**Office of Enterprise Assessments
Review of the Hanford Site
Waste Treatment and Immobilization Plant
Construction Quality**

June 2015

**Office of Nuclear Safety and Environmental Assessments
Office of Environment, Safety and Health Assessments
Office of Enterprise Assessments
U.S. Department of Energy**

TYPICAL 3 PHASE 120/208 PANEL

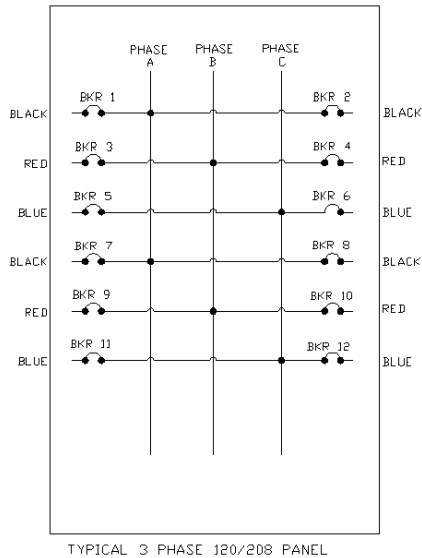
As mentioned above, the WTP site has a standard electrical color code of black for Phase A, red for Phase B, and blue for Phase C for low-voltage 3-phase panels. A typical panel is shown below:
